# Access Compliance Report

### (Curb Ramps)

Intersection ID: 7901	Main Street: GLENMOOR_DR	Cross Street: LITTLE_ROCK_RD	Location: S
ADA ID: A15F7DFDDDEF	Ramp Type: Perp	Initial Pass/Fail: Fail	Overall Compliance: No
Severity Score: 8.75			
Codes/Mitigation Info/Possible Solution		Field Measurements/Component Compliance

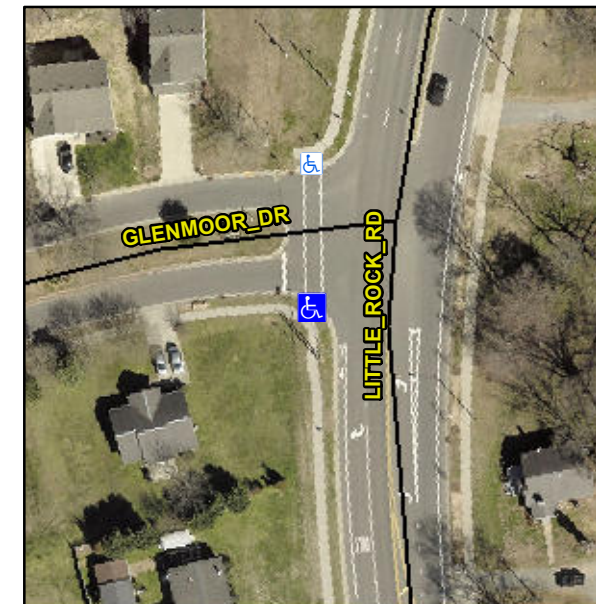
**Not Found, R304.5.1**

Compliance	Description	Data	Compliance	Description	Data
N/A	Ramp Length (in)	81.0	Yes	Ramp Slope (%)	7.6
No	Ramp Width (in)	47.0	Yes	Ramp XSlope (%)	0.5
N/A	Flare Type LT	N/A	N/A	Flare Type RT	N/A
N/A	Flare Slope LT (%)	N/A	N/A	Flare Slope RT (%)	N/A
N/A	Flare Traversable LT?	N/A	N/A	Flare Traversable RT?	N/A
N/A	Landing Length (in)	N/A	N/A	DWS Provided?	N/A
N/A	Landing Width (in)	N/A	N/A	DWS Contrast?	N/A
N/A	Landing Slope (%)	N/A	N/A	DWS Length (in)	N/A
N/A	Landing X Slope (%)	N/A	N/A	DWS Full Width?	N/A
N/A	Landing Curb? (Y/N)	N/A	N/A	DWS Offset (in)	N/A
N/A	Shared Landing?	N/A			
N/A	Gutter Ponding?	N/A	N/A	Gutter Slope (%)	N/A
N/A	Gutter Lip Ht (in)	N/A	N/A	Gutter X Slope (%)	N/A
N/A	Painted X Walk1?	Yes	N/A	Painted X Walk2?	N/A
	X Walk 1 Direction	To N		X Walk 2 Direction	N/A
N/A	X Walk 1 Width (in)	97.5	N/A	X Walk 2 Width (in)	N/A
	X Walk 1 Slope (%)	1.6		X Walk 2 Slope (%)	N/A
	X Walk 1 X Slope (%)	0.9		X Walk 2 X Slope (%)	N/A

N/A	Ramp inside XWalk1?	Yes	N/A	Ramp inside XWalk2?	N/A
	Road Slope (%)	N/A	N/A	Clear Space?	N/A
	Road X Slope (%)	N/A	N/A	Clear Space to XWalk (in)	N/A
N/A	Any Obstructions?	N/A	N/A	Storm Grate/Utility Hazard?	N/A
	Obstruction Type			Storm Grate/Utility Type	
		N/A			N/A
		Yes		Surface Condition? (G/P)	Good

**Remove & Replace Entire Ramp.**
